STATE OF RHODE ISLAND AND PROVIDENCE PLANTATION
DEPARTMENT OF TRANSPORTATION
RHODE ISLAND CONTRACT NO.2012-CH-082
FEDERAL-AID PROJECT NO. FAP Nos: STP-0044(062), STPG-0044(063)

Imp. to Rte. 44 Contract 2B - Austin Avenue to Danecroft Avenue

NOTICE TO PROSPECTIVE BIDDERS

ADDENDUM NO. 1 Prospective bidders and all concerned are hereby notified of the following changes in the Plans, Specifications, Proposal and Distribution of Quantities for this contract. These changes shall be incorporated in the Plans, Specifications, Proposal and Distribution of Quantities, and shall become an integral part of the Contract Documents.

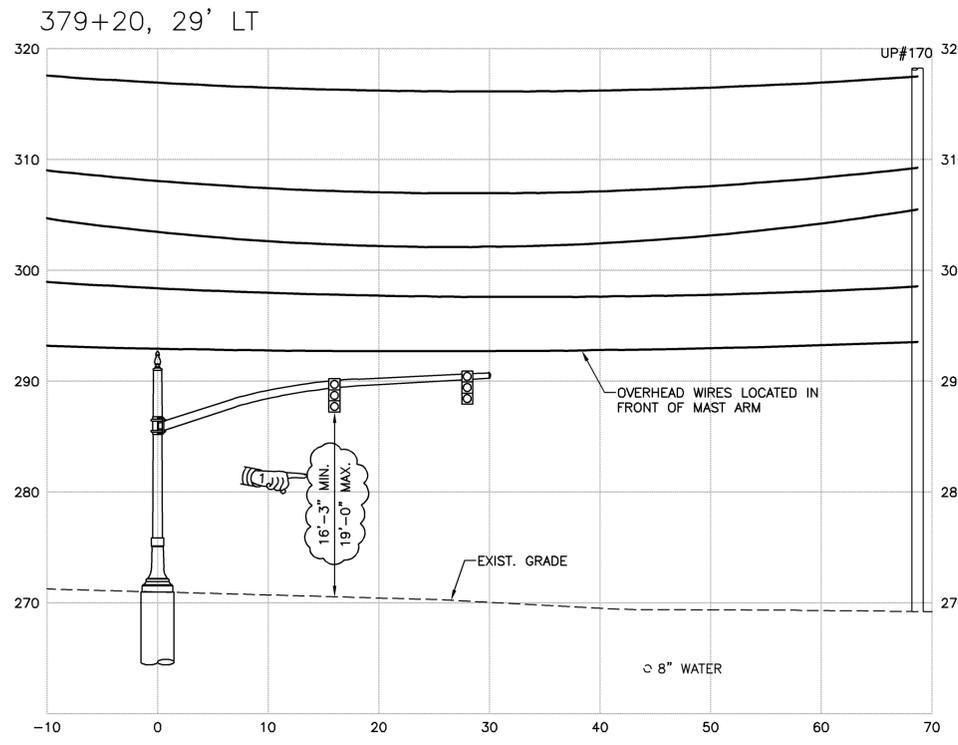
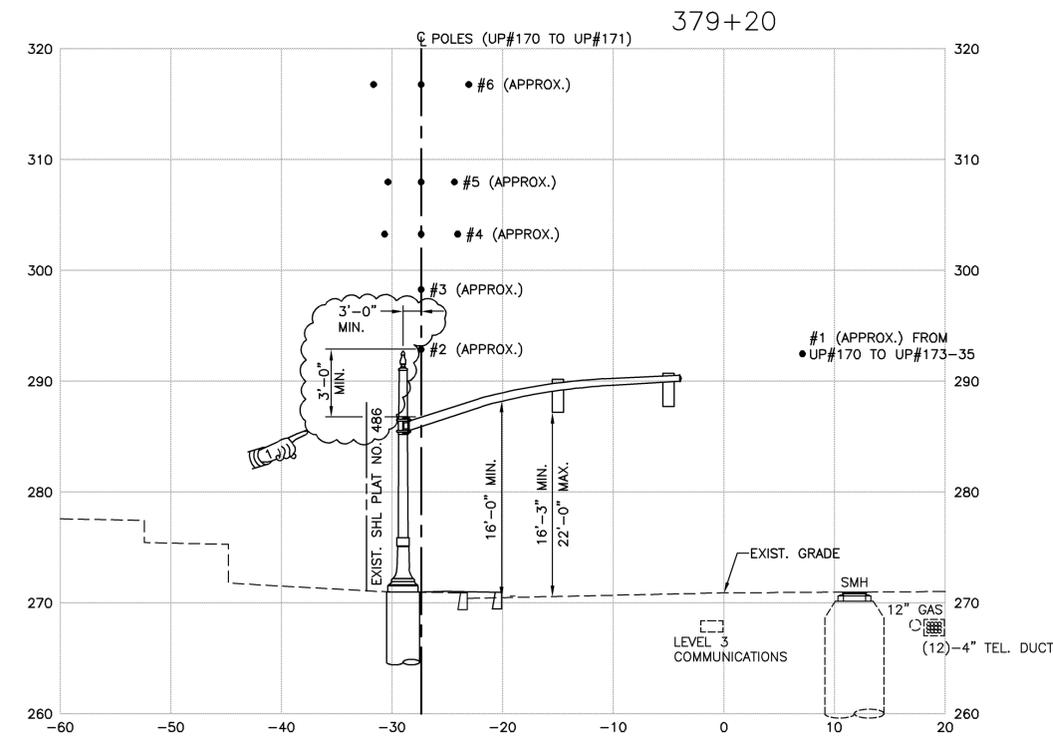
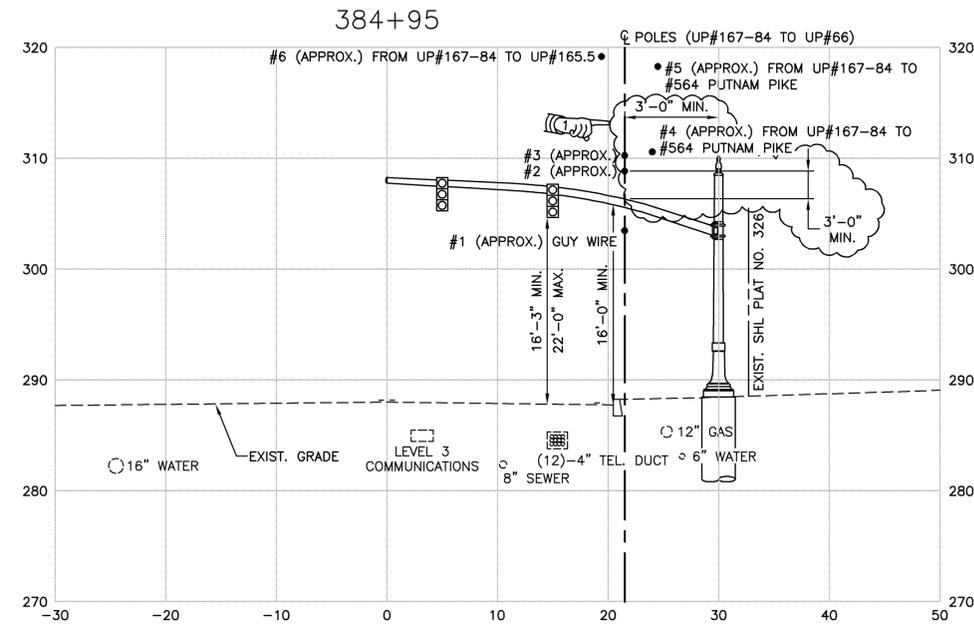
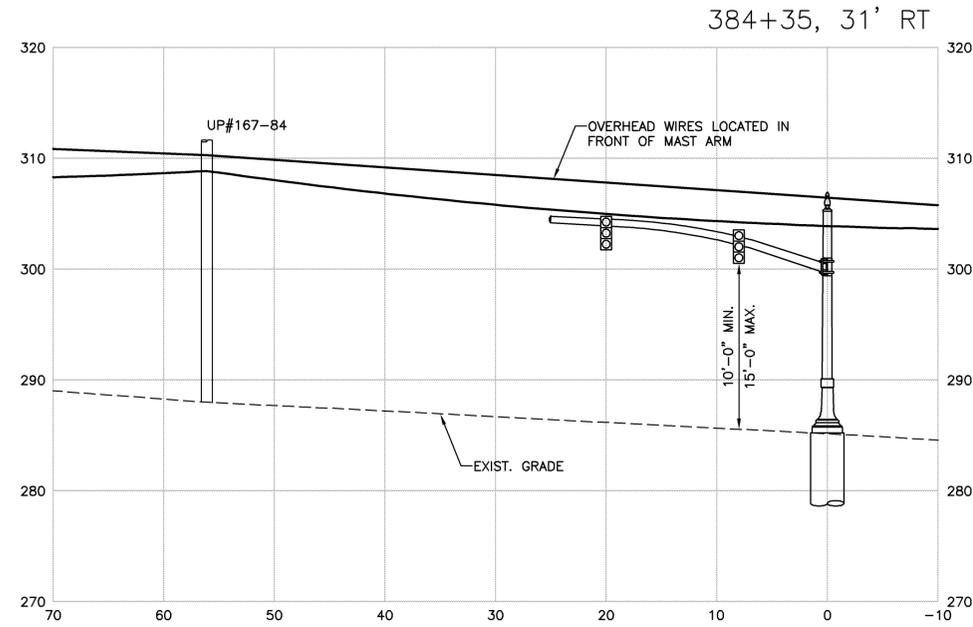
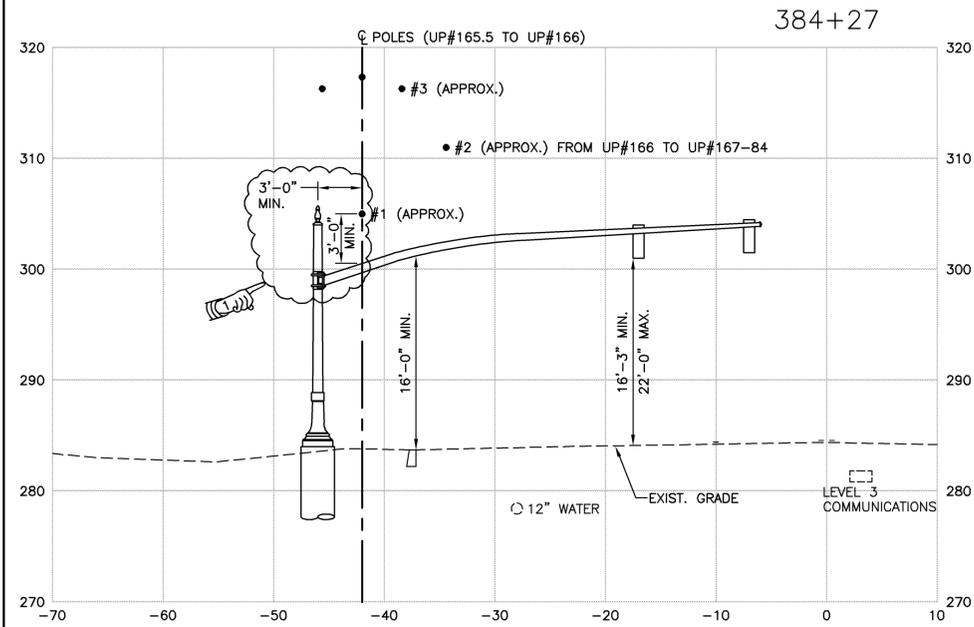
Remove Sheet No. 46 (Traffic Signal Mast Arm Cross Sections) in its entirety and replace it with revised Sheet No. 46(R-1) attached to this Addendum No. 1. Overhead wire radial clearances have been added.
